Addendum Number 1

Police Department Rooftop HVAC Unit Removal & Replacement Project <u>Issued February 26, 2025</u>

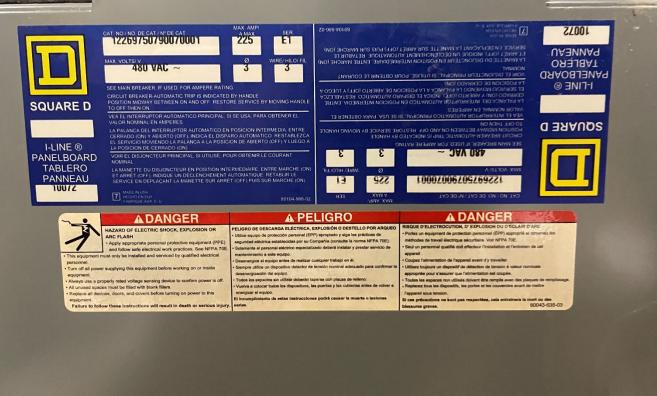
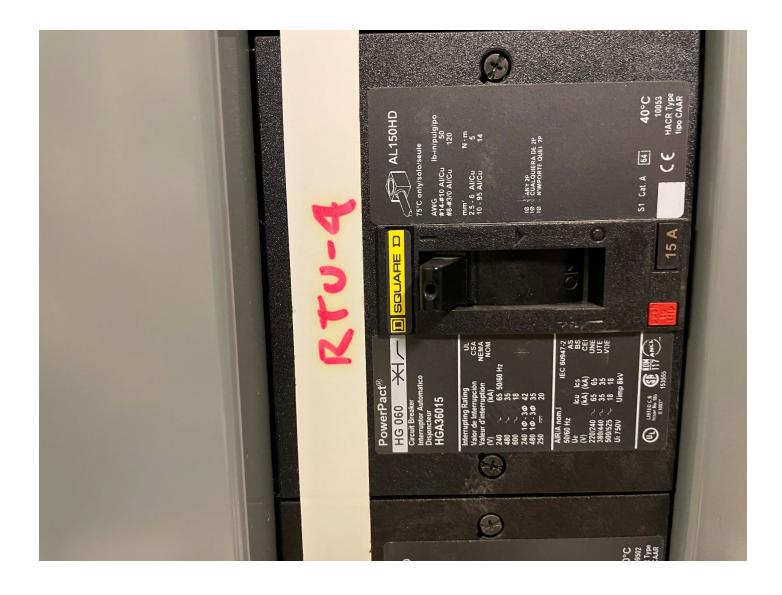
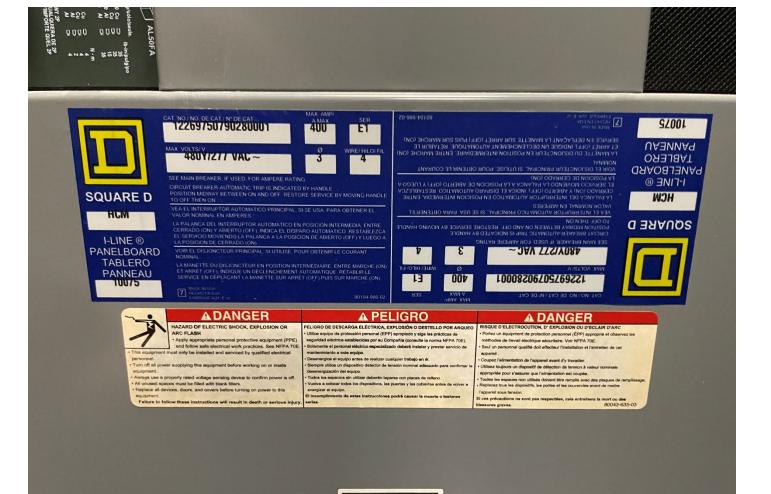
Q5. Can you provide information on the electrical panels and existing breaker sizes for the units to be replaced?

A5. Below is the panel information and equipment schedule from the buildings plans along with a photo of the panels for the RTUs to be replaced.

RTU-3 was installed on this panel in spaces 37-41.

ONE LINE DIAGRAM

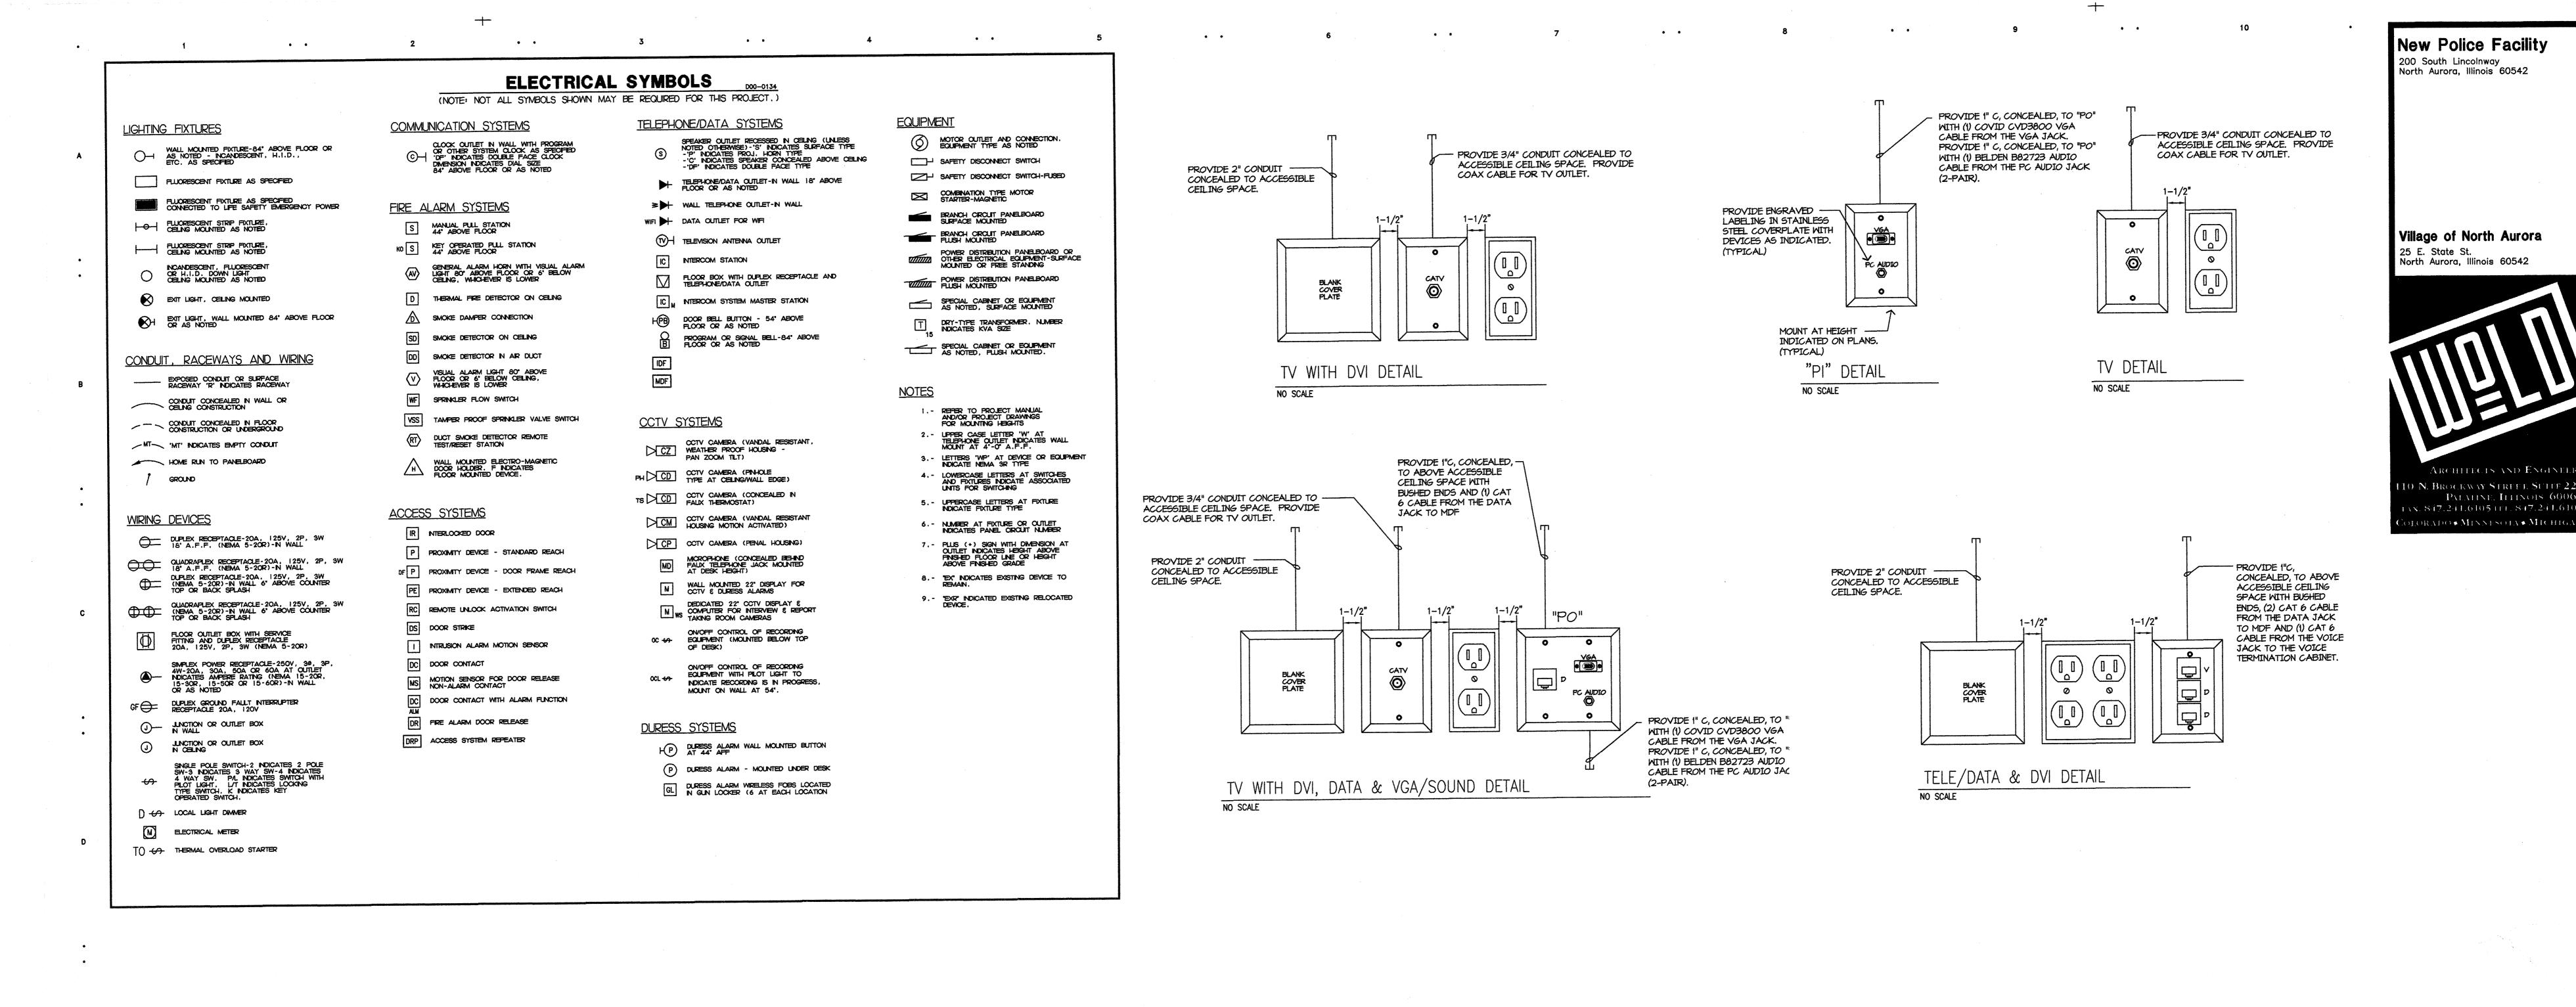
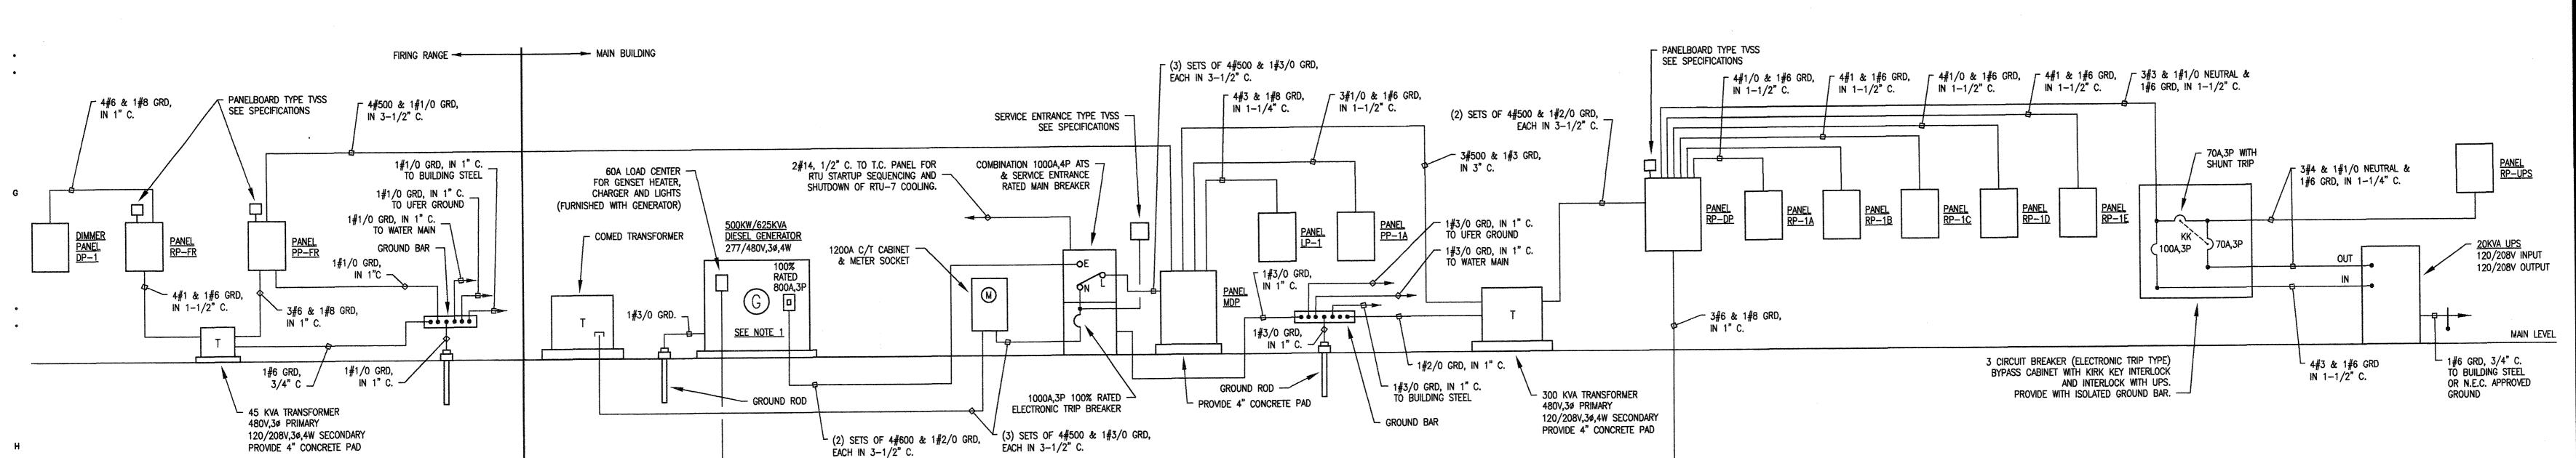
Q2. Does the buildings electric have a high delta leg?

A2. Please see the one-line diagram of the electric, provided on the attached plan sheet for information on the electrical service.
